MEMORANDUM

SUBJECT: Review comments on Physical Characterization Technical Memorandum for the West Lake Landfill OU2, Bridgeton, Missouri

The following memorandum presents review comments stemming from the review of the Physical Characterization Technical Memorandum for the West Lake Landfill OU2, dated August 1996.

Golder Associates Denver, Colorado		TITLE TYPICAL PIEZOMETER CONSTRUCTION DETAILS		
CLIENT/PROJECT  LADLAN LADLAN WASTE SYSTEMS INC.		WEST LAKE LANDFILL		DRAWN TMC DATE AUGUST 1996 JOB NO. 943-2848 CHECKED CER SCALE AS SHOWN DWG NO./REV. NO. A034 REVIEWED WEH FILE NO. 2848A034 FIGURE NO. 3-2

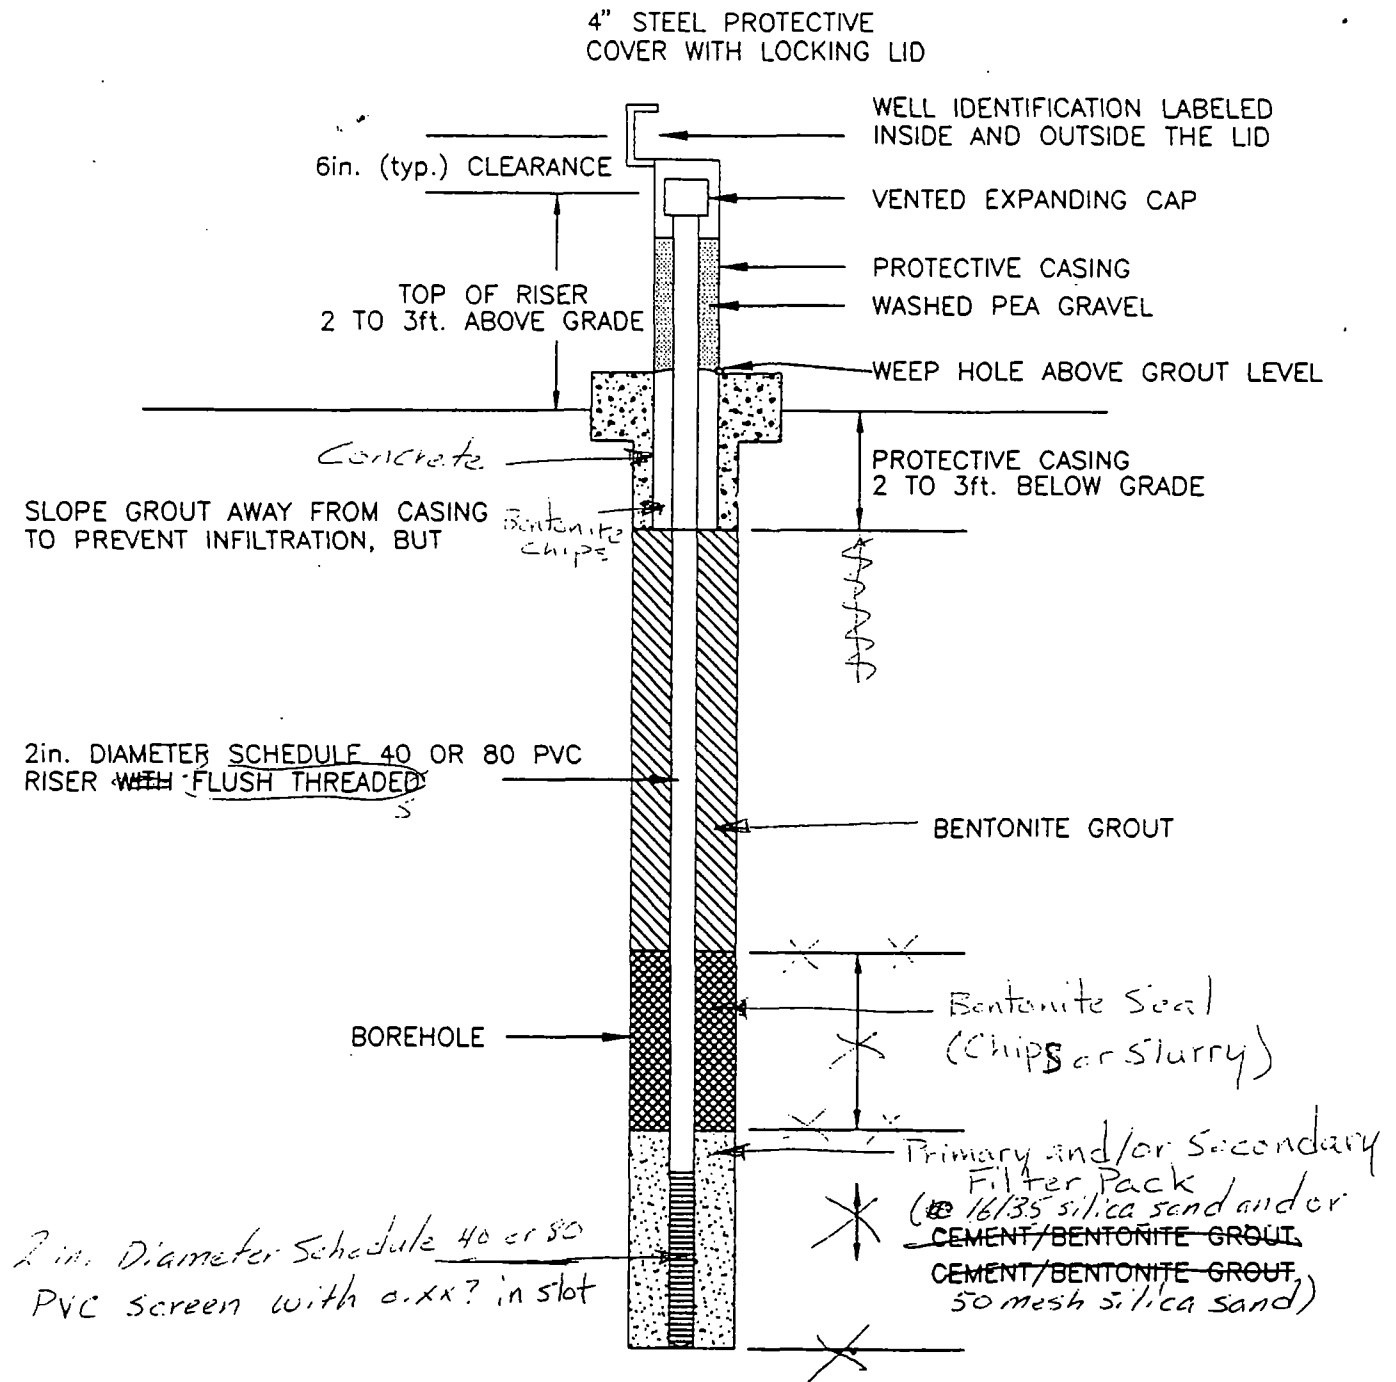
- Figure 3-2 This figure does not match the description given the text. Attached is a marked-up copy indicating errors and suggested corrections. In the figure it would appear that the annular space around the screen is backfilled with cement/bentonite grout. The sentence 'Slope grout away from casing to prevent infiltration, but' seems to be incomplete.

- 3.2.2.1-General It is unclear from the text what the annular space above the bentonite seal is backfilled with. Figure 3-2 indicates that a bentonite grout was used.
